COLORADO DIVISION OF RECLAMATION, MINING AND SAFETY
MINERALS PROGRAM INSPECTION REPORT
PHONE: (303) 866-3567

MINE NAME: San Luis Project	MINE/PROSPECTING ID#: M-1988-112	MINERAL: Gold and silver	COUNTY: Costilla
INSPECTION TYPE: Multi Person Inspection	INSPECTOR(S): Wallace H. Erickson, G. Russell Means	INSP. DATE: May 13, 2013	INSP. TIME: 10:00
OPERATOR: Battle Mountain Resources, Inc.	OPERATOR REPRESENTATIVE: Julio Madrid, Steve Carino, Jim Witweir	TYPE OF OPERATION: 112d-3 - Designated Mining Operation	
REASON FOR INSPECTION: Citizen Complaint	BOND CALCULATION TYPE: Partial Bond	BOND AMOUNT: \$7,400,000.00	
DATE OF COMPLAINT: NA	POST INSP. CONTACTS: Complainant, OSE Dam Safety	JOINT INSP. AGENCY: OSE, DWR, Dam Safety, Mark Perry, PE	
WEATHER: Cloudy	INSPECTOR'S SIGNATURE: <i>Wallace H. Erickson</i>	SIGNATURE DATE: September 11, 2013

ENGINEER'S INSPECTION REPORT

DAM NAME: BATTLE MOUNTAIN SAN LUIS TAILINGS T: 0 R: 0 S: COUNTY: COSTILLA DATE OF INSPECTION: 5/13/2013
 DAM ID: 240109 YR Compl: 1991 DAM HEIGHT(FT): 140.0 SPILLWAY WIDTH(FT): 4.0 PREVIOUS INSPECTION:
 CLASS: N hazard DAM LENGTH(FT): 1640.0 SPILLWAY CAPACITY(CFS): 170.0 NORMAL STORAGE (AF): 750.0
 DIV: 3 WD: 24 CRESTW

San Luis Project
M-1988-112
May 13, 2013
DRMS Photo 3

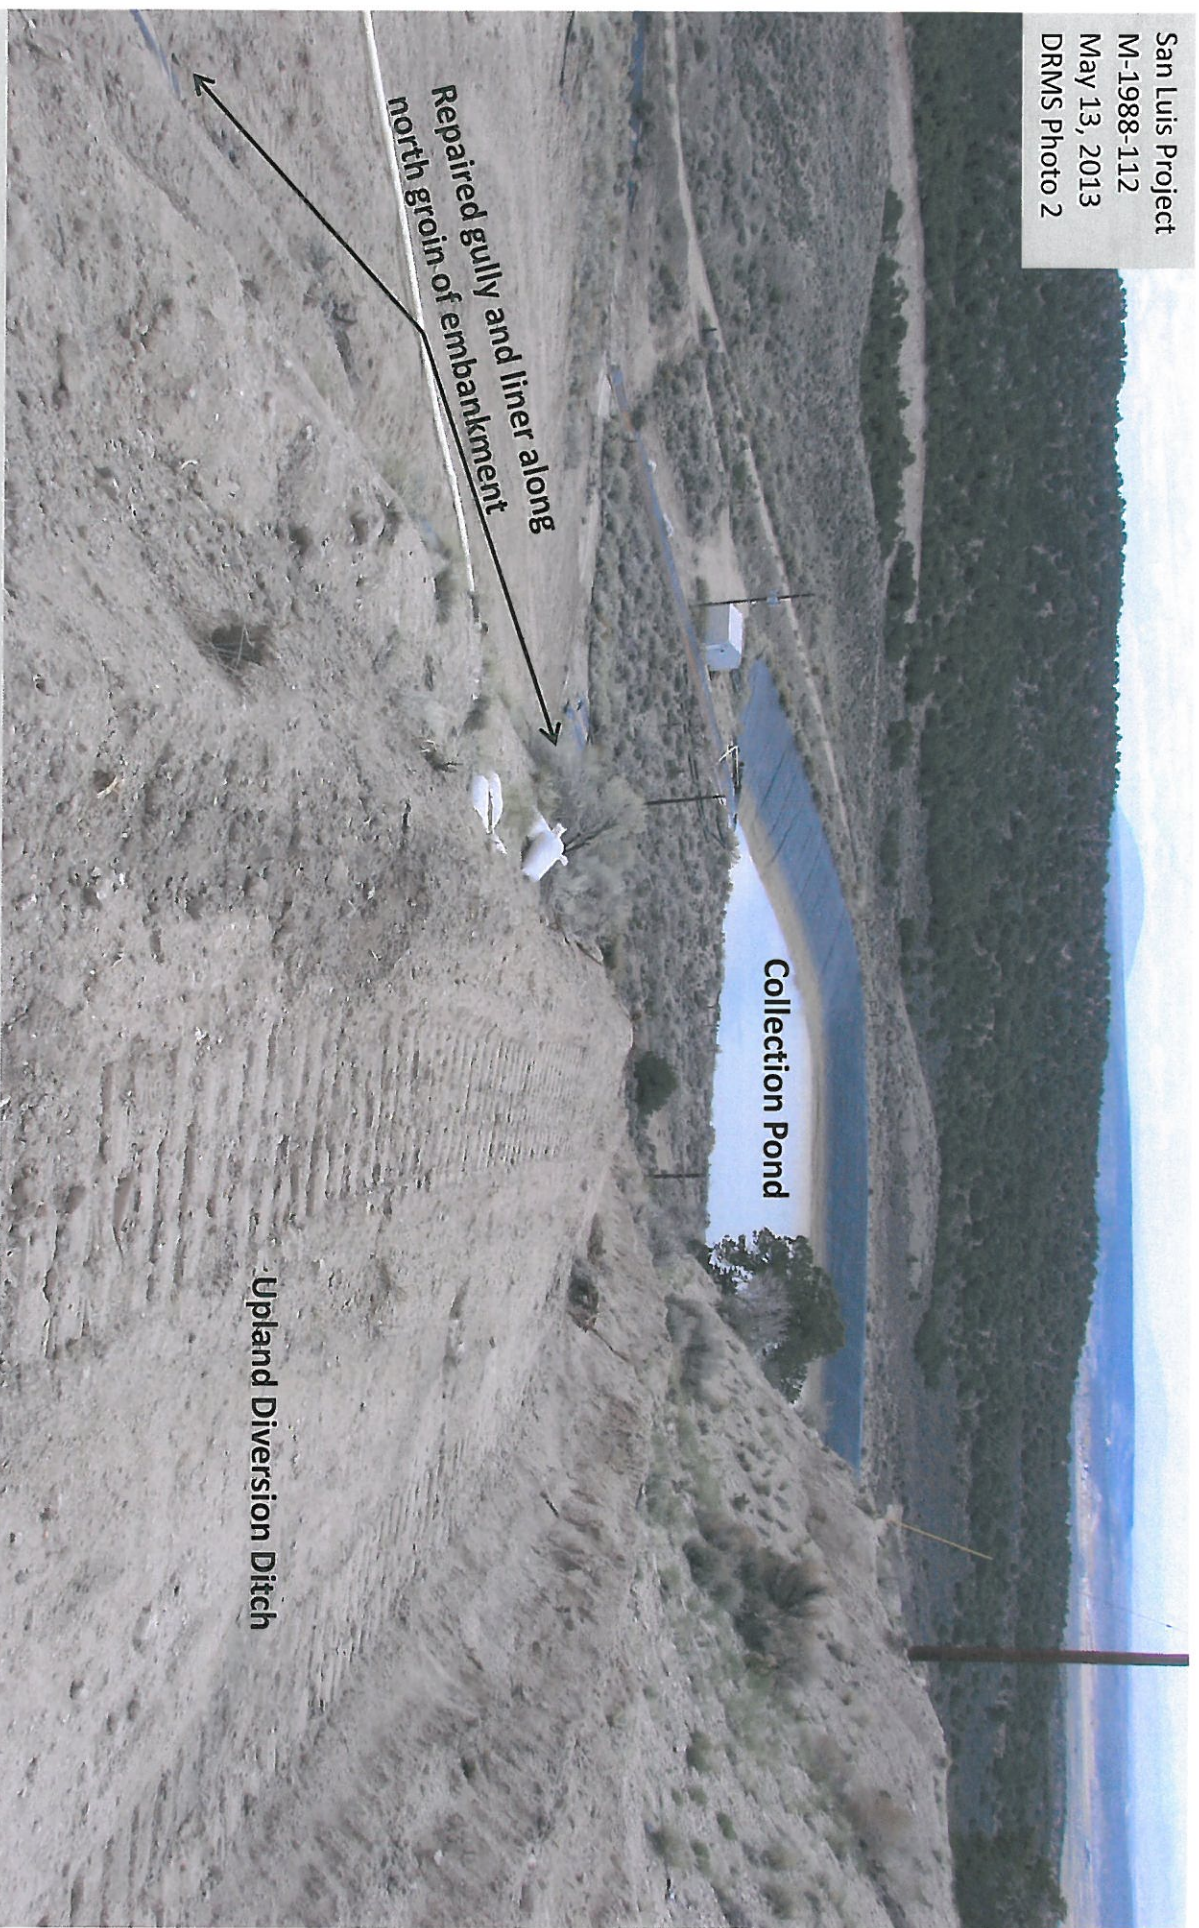
As shown in DRMS Photos 3 and 4, there is a seep associated with the outlet of the drainage blanket for the tailing pond. Flow rate from the outlet was estimated at 30 gpm and consistent with monthly flow reports recorded by the Operator. Although the outlet appeared to have sufficient capacity to function in accordance with the approved designs, routine maintenance to the outlet, to include sediment clean-out and stabilization of the slope immediately above the outlet, is required to ensure its continued function.

View east, taken at the downstream toe of the main embankment for the tailing pond, showing the outlet of the drainage blanket and a seep associated with the outlet. The origin of the seep, current condition of the drain pipe through the base of the embankment, and any necessary repairs to the outlet must be addressed in the initial engineering report required through TR-33.

The drainage blanket for the tailing pond and its associated outlet through the embankment are essential components of the tailings repository. As recommended in the enclosed Engineer's Inspection Report from Mr. Perry, the configuration of the existing drain-pipe upstream of the outlet, and the origin of the seep shown in photo 3, must be verified. Such investigations shall occur through the inspection and reporting program approved through TR-33. Any alteration to previously approved designs must be submitted for review and approval through the Technical Revision or Amendment process defined under Rules 1.9 and 1.10.

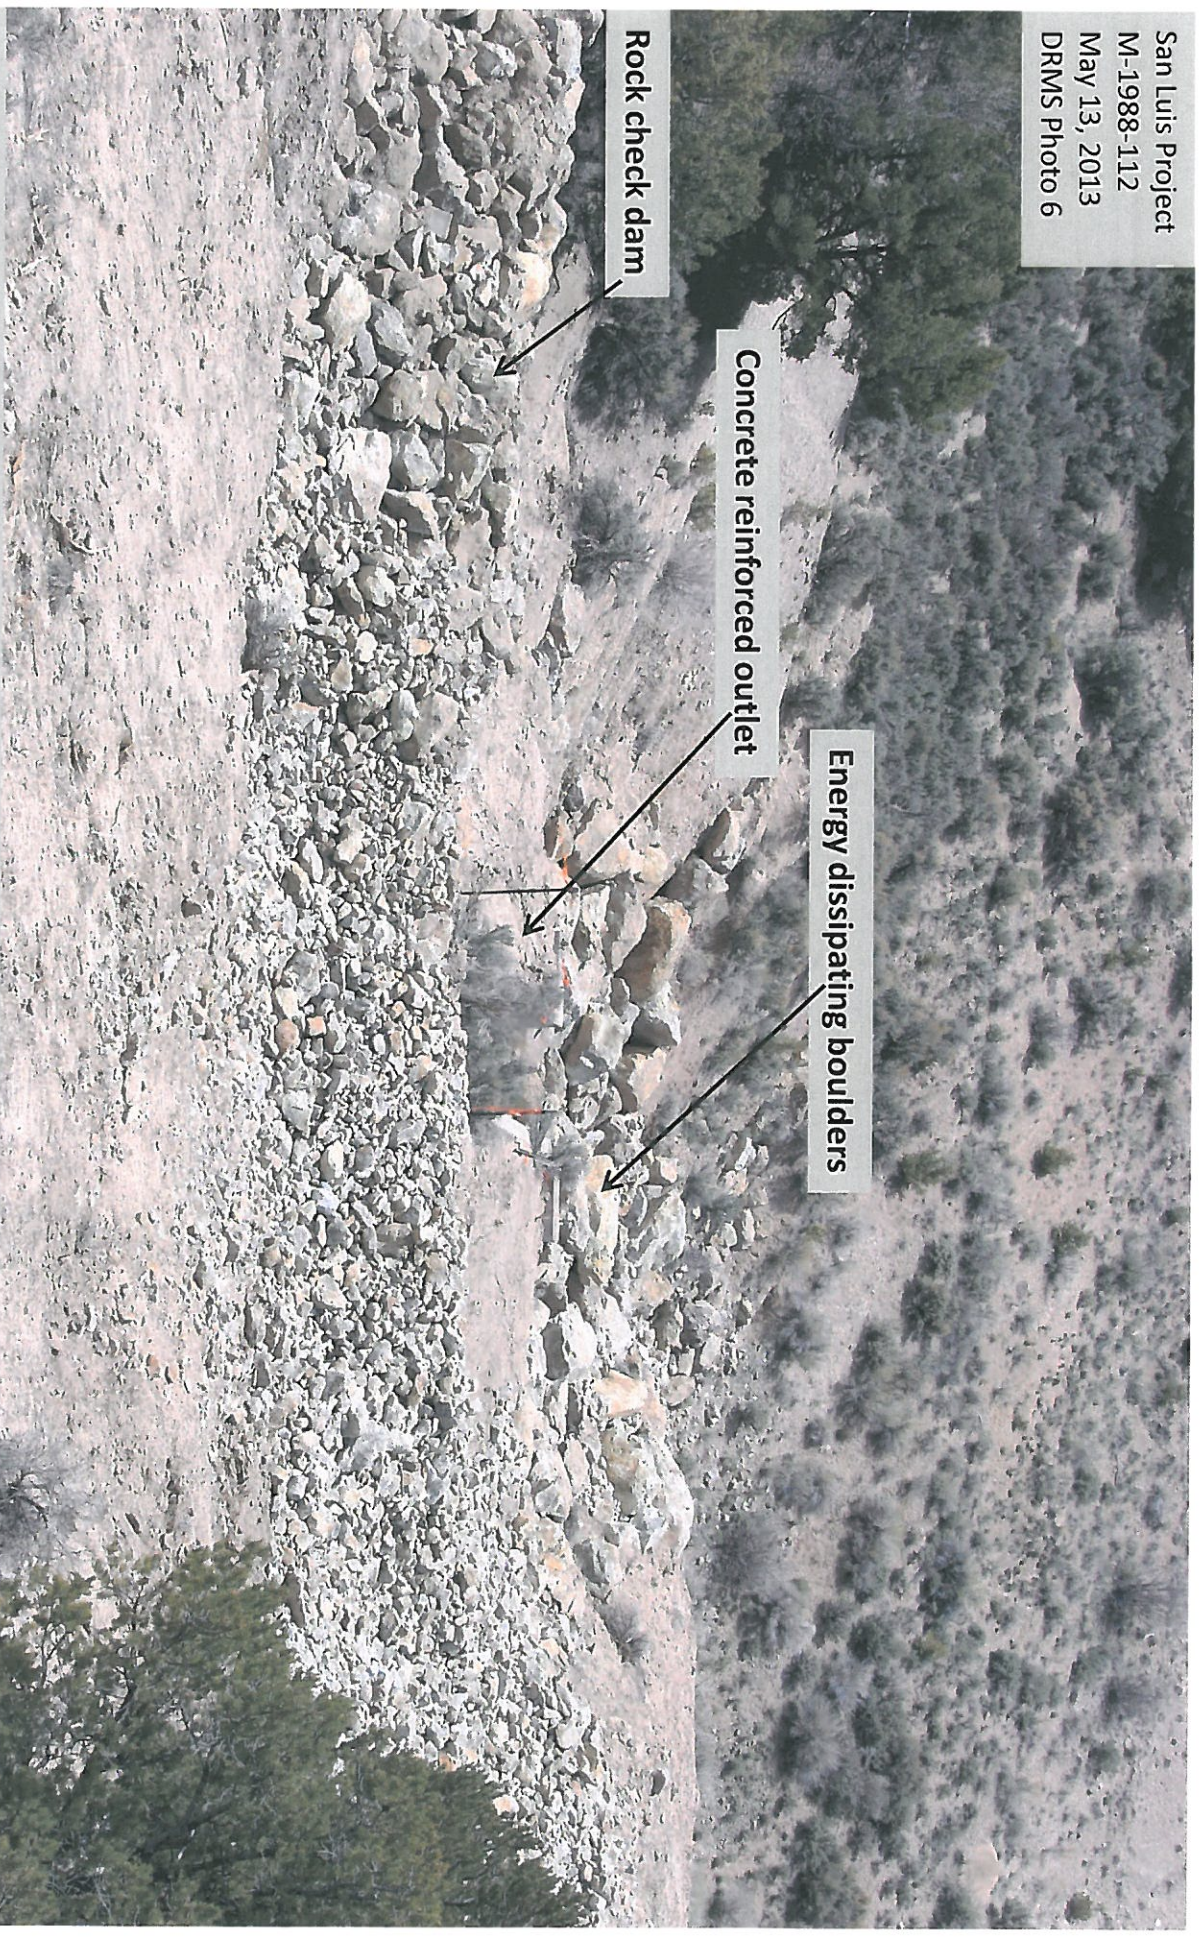
As shown in DRMS Photos 5 and 6, all portions of the south diversion ditch proximal to the embankment of the tailing pond appeared stable; evidence of erosion/sedimentation was not observed. However, as shown in photo 5, the inlet for the drop structure was not protected by a debris screen. As recommended by Mr. Perry, a properly designed debris screen appears essential to ensure the continued function of the drop structure. Please ensure the initial engineer inspection and report, required through TR-33, addresses the issue. If the engineer inspection and report recommends a debris screen, such plans must be submitted for review and approval through either the Technical Revision or Amendment process, described under Rules 1.9 and 1.10, prior to construction.

View west, showing portions of the upland diversion ditch for the south side of the tailings repository, and the inlet of its associated drop structure located at the crest of the embankment. The south upland diversion structure is designed to safely convey flows up to and including the 100 year, 24 hour storm event. Permit documents define the 100 year, 24 hour storm event at 2.9 inches precipitation and calculate storm runoff from the south drainage area at 292 cfs. As shown in this photo, the inlet of the drop structure did not include a debris screen.

•We observed that there is no trash rack on the drop structure intake. The SEO typically recommends a self-cleaning type trash rack for the intake of a closed conduit spillway in order to prevent clogging.

- ☒ (97) OTHER: **Consider installing a trash rack at the south diversion drop structure inlet.**
- ☒ (98) OTHER: **Perform an internal inspection of the south diversion drop structure conduit. ALSO we recommend evaluating how the Maximum Normal water level is controlled in both the main tailings dam and the seepage collection pond (See spillway sect. of this report).**

Photo 9 – Seepage drain outfall at the downstream toe (3x12" HDPE pipes). There is reportedly a large seepage collection pipe under the dam. NOTE: Uncontrolled seepage exiting higher on the slope above the drain outfalls (red arrow).

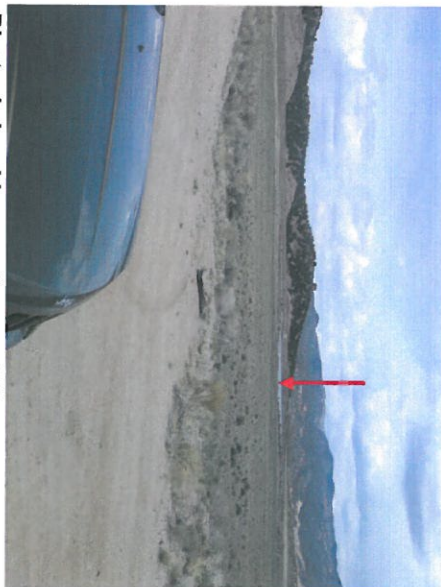
•Uncontrolled seepage was observed exiting ~6-ft above the 12" HDPE drain outfalls on the downstream slope of the main embankment.

Photo 8 – Seepage at toe of the main dam. Majority of seepage comes through collection drain, but some seepage appears to be uncontrolled (see Photo 9).

(1) research to determine the design of the seepage collection pipe system under the embankment, and (2) after determining the design of the pipe collection system, determine if it is feasible to video inspect the pipes. The SEO recommends that internal outlet conduit video inspections be performed at least every 10 years for SEO-regulated High and Significant Hazard dams.

- ☐ (93) PERFORM A HYDROLOGIC STUDY TO DETERMINE REQUIRED SPILLWAY SIZE:
- ☐ (94) PREPARE PLANS AND SPECIFICATIONS FOR AN ADEQUATE SPILLWAY:
- ☒ (96) PERFORM AN INTERNAL INSPECTION OF THE OUTLET: **Determine the design of the seepage collection pipe system under the embankment. If possible video inspect the pipes. Determine source of uncontrolled seepage exiting on downstream slope above collection drain outfalls**
